Ms. Brenda Edwards  
U.S. Department of Energy  
Building Technologies Office  
Mailstop EE-5B  
Energy Conservation Standards for Residential Furnaces  
EERE-2014-BT-STD-0031  
1000 Independence Avenue SW  
Washington, DC 20585-0121

Re: Notice of Data Availability for Energy Conservation Standards for Residential Furnaces, Docket # EERE-2014-BT-STD-0031

Figure 2

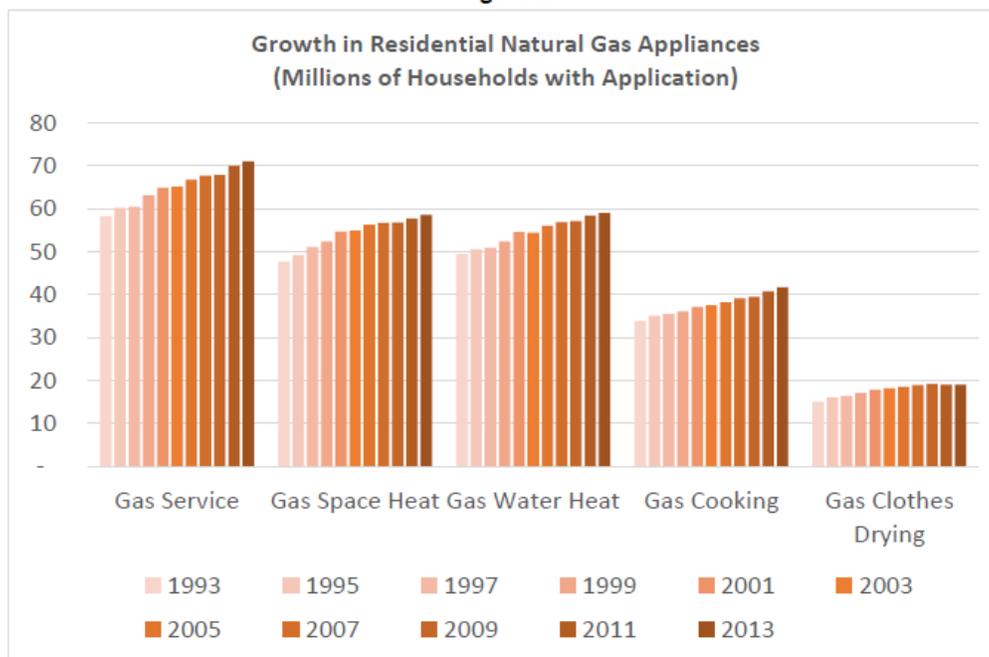
According to the September 2015 AGA report, there may be a strong correlation between gas furnace installations and installations of other gas appliances (especially water heaters and cooking equipment): “In many cases, the past two decades of growth (Figure 2) have featured additional natural gas space heating with an additional 10.9 million homes reporting natural gas space heating applications and 9.6 million more homes with water heaters. One third of new additions were for cooking and clothes drying given 7.86 million homes with natural gas cooking were added and nearly 4 million homes adding natural gas clothes dryers.”<sup>12</sup>

Because DOE has elected to assess the impact of switching from gas furnaces to electric heating systems on other end-use appliances (primarily water heaters), they should be thorough and extend that analysis to include the impacts of switching from heat pumps to gas furnaces on the use of other end-use appliances as well. If DOE is going to assess fuel switching as part of the analysis in support of revised furnace standards, it is unreasonable to conduct what is really only half of the necessary review.

**Figure 10.5.1 Primary to Site Energy Use Factor for Non-Weatherized Gas Furnace and Mobile Home Gas Furnace Electricity Use, 2021-2040**

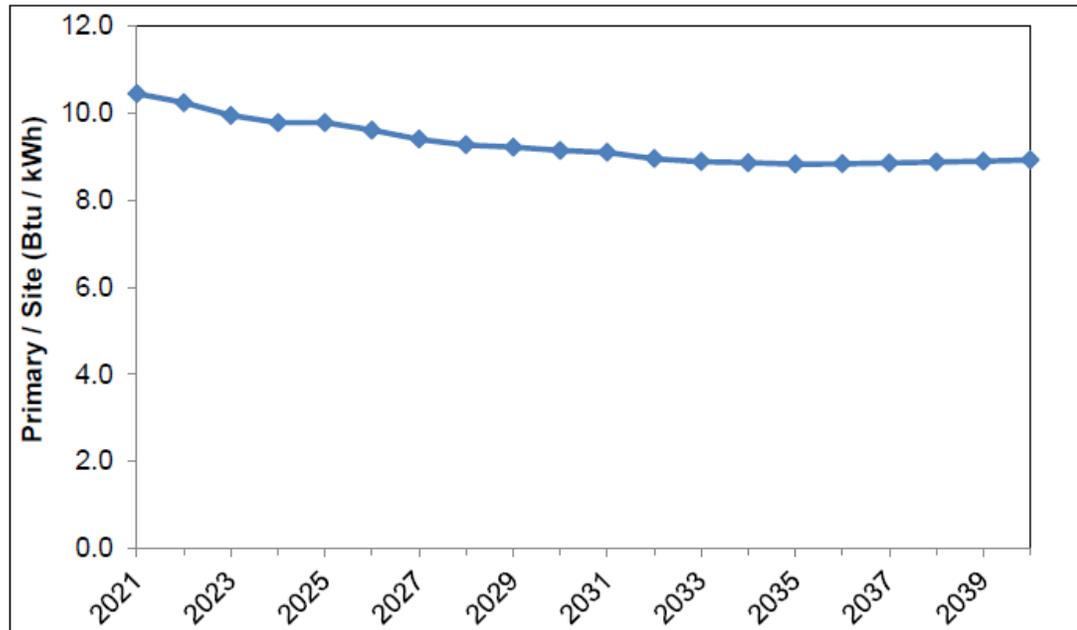
As part of the fuel switching analysis, DOE used a “site to source” use factor that is flawed. As part of the TSD, DOE published the following graph, depicting the “site to source” conversion factor that was used, which is based on the National Energy Modeling System’s (NEMS) model and used AEO 2014 inputs:

As discussed in our July 24 Comments, the conversion factor estimates depicted in Figure 10.5.1 are overstated for the following reasons: 1) they do not account for the changes that are occurring now and in the future due to the CPP; 2) they reflect a national number, which ignores the significant variation in electric generation by power pool region; and 3) they incorrectly “assign” of a fossil fuel heat rate to renewable electric generation. Further, inexplicably, the accompanying spreadsheet shows the conversions factor actually increasing slightly from 2035 to 2040 (from 8.971 to 9.059), without explanation and shows no improvement from 2040 on. This post 2035 increase does not comport with the expected fuel mix that will be generating electricity post-2030.

In addition, DOE continues to use an annualized number for an appliance that only operates primarily during the winter season. In terms of seasonality, this is especially important when considering the amount of wind electricity being generated now and in the future. According to EIA data, capacity factors and electricity output are higher in the winter months than in the summer months.<sup>13</sup> In northern states, the differences between winter and summer production are quite significant. Assuming that these seasonal appliances run year round overstates their energy use. Further, if DOE is going to use annualized data, it should recognize that winter usage often corresponds with the use of more renewables.
